Office Action Summary	Application No. 10/596,583	Applicant(s) NIEVES-VAZQUEZ, ENRIQUE	
	Examiner Tony G. Soohoo	Art Unit 1774

DETAILED ACTION**Claim interpretation**

2. Claims 1-4, 12 and 17 are rejected under 35 U.S.C. 102(b) as being anticipated by DE 85 13 987 (cited as a “x” reference in the EP supplemental search report).

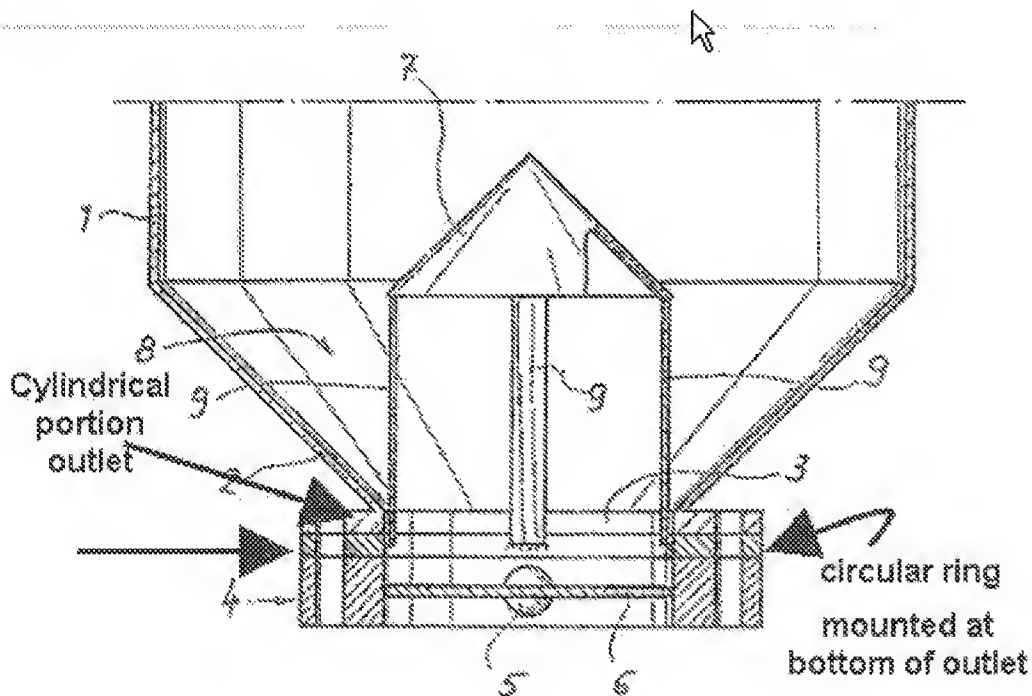
The DE reference shows a hopper 1; lower outlet 3 at bottom of 2 and at 4; a flow controller including a conical deflector 7 being carried by an upper end of a support structure with spaced legs 9, 9, 9; a mounting portion ring (see markup) in contact with

the bottom of the outlet cylindrical portion; a frusto conical portion 2 which narrows from 1 to outlet 3.

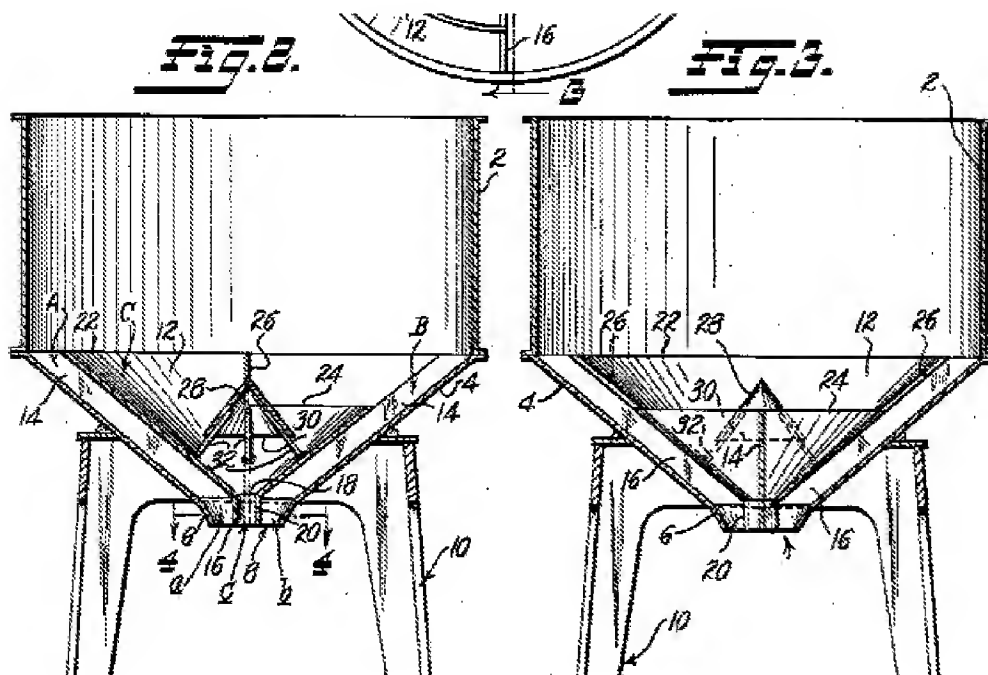
Regarding claim 12 note that the legs 9 are spaced about 3.

Regarding claim 17 note that the conical deflector upward portion is a face the solid conical surface.

Regarding claims 15, the DE reference shows the legs 9 attached to a circular ring (see the sandwiched section attached to the bottom of the outlet in the markup above). The reference is silent as to the sandwiched portion being fixedly attached or removable from the hopper outlet. It would have been obvious to one having ordinary skill in the art at the time the invention was made to make the mounting portion circular ring detachable from the bottom of the outlet so as to provide an easy manner to repair/replace a damaged or dented deflector, since it has been held that constructing a formerly integral structure in various elements involves only routine skill in the art. *Nerwin v. Erlichman*, 168 USPQ 177, 179.
